From:**Sent:** 02 December 2021 14:10**To:** Kelsey Blain**Cc:****Subject:** Your ref NYM/2021 / 0862/ CLLB

CLIENT: Ilona Franklin			
PROJECT: Woodleigh House Aislaby			
A3	DRN: Marie Kay	DATE: 01.12.2021	
SCALE: 1:2		ISSUE: Preliminary

DRAWING TITLE: Vertical sliding sash window detail	
DRAWING NR: D12164-11	REV: A

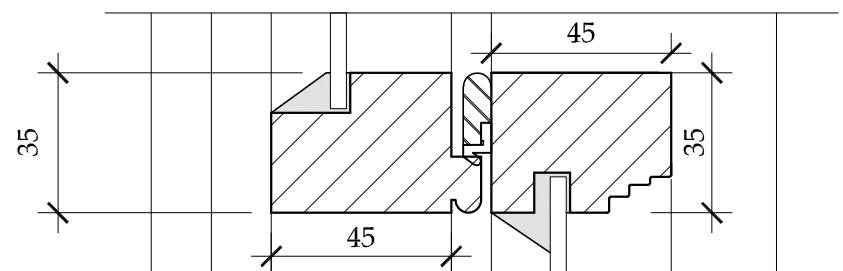
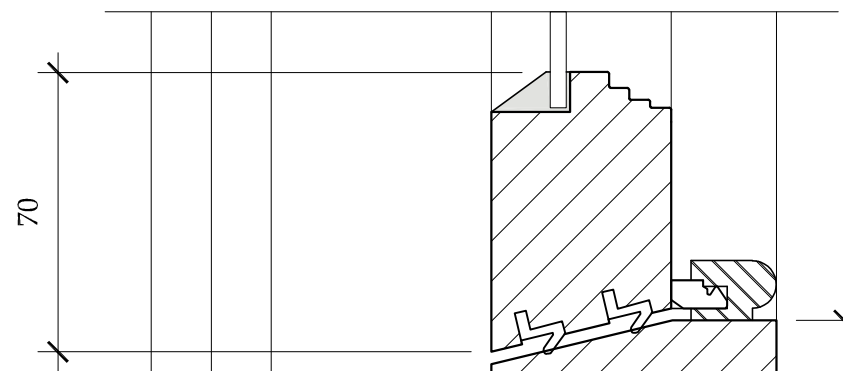
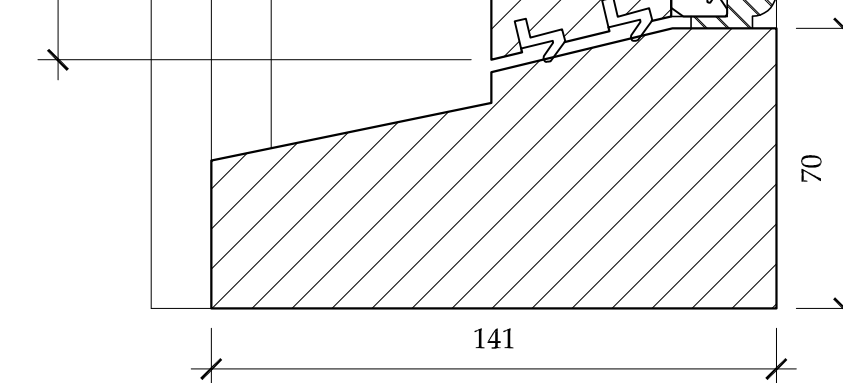
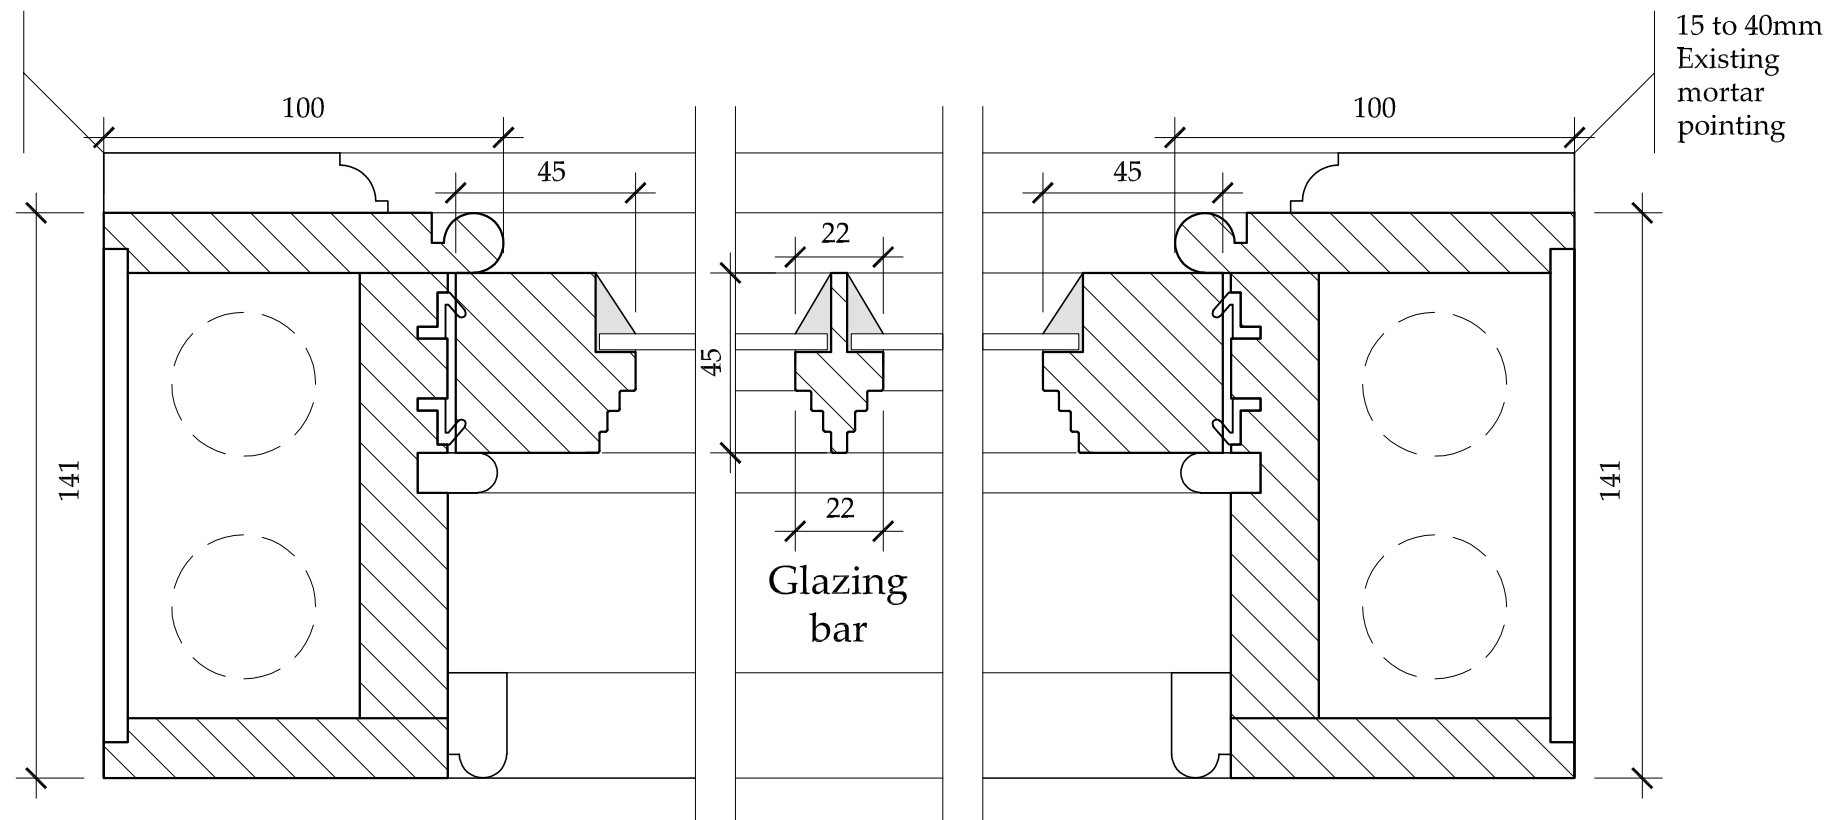
Further to your letter dated 24th November 2021 (copy attached) and received by e-mail on 25th November 2021 with requests for further information I am writing to confirm the following :

- Cross Sectional details of the windows are attached as requested.
- Because the application is for “ like-for-like ” replacement windows then the existing and proposed cross sectional details are the same and for this reason only one drawing is provided which applies .

- The thickness of the existing glass is generally in the region of 4mm float glass.

- Single glazed windows using 4mm float glass and putty pointed externally using traditional linseed oil putty
